Re: Proposal Review
MGT PR 30 – Plumbing change Unisex 145B, IDF 145A, Shift Supervisor 147 and
Dispatch 146A.
Emergency Operations Center Phase 1B
Lexington Fayette Urban County Government
Lexington, Kentucky
Marcum No. 13618

Subject: Plumbing Modification Unisex 145B, IDF 145A, Shift Supervisor 147, and 911 Dispatch 146A

SUBJECT: RFP 4 – Plumbing Modification Unisex 145B, IDF 145A, Shift Supervisor 147, and 911 Dispatch 146A.

XP04

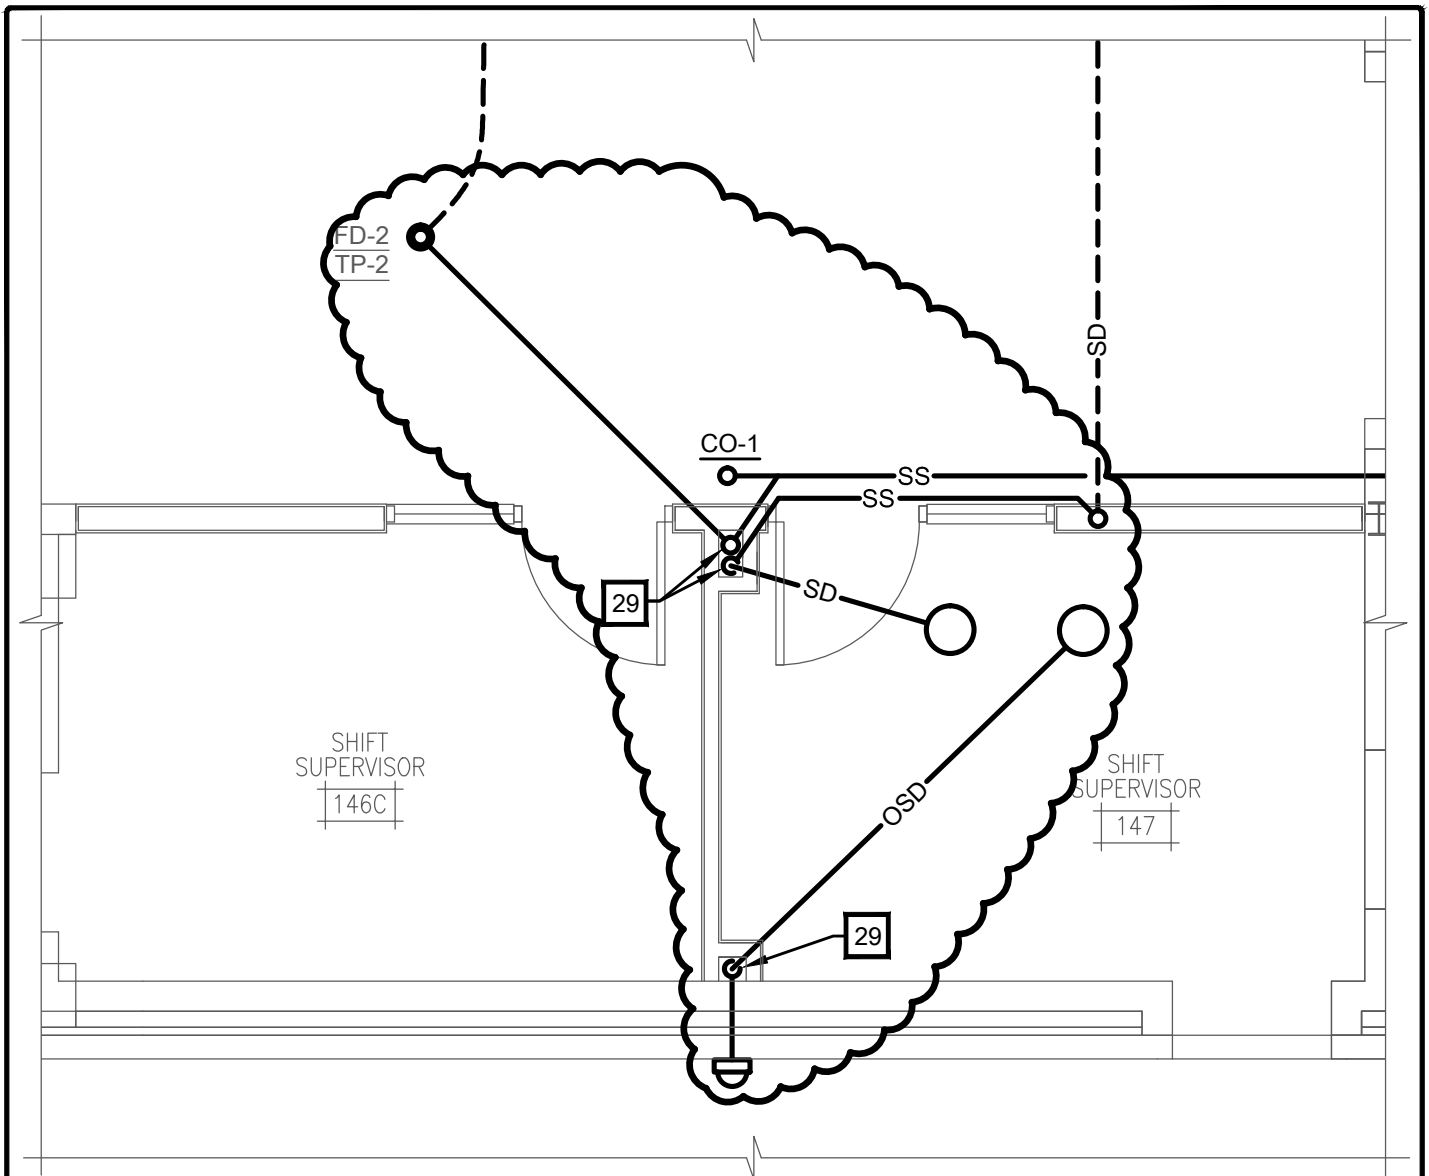
The Contractor shall modify the storm drain piping, overflow piping, sanitary drains and vents, trap primer piping and domestic water piping as depicted in Sketches XP04 and XP05 to accommodate the revised floor plan.

The Contractor shall provide a proposal to furnish and install (1) additional FD-3 floor sink as shown on Sketch XP04. Floor sink shall be installed under raised floor and 1" above concrete slab below.

REVISED PLUMBING AT 145A & 145B.
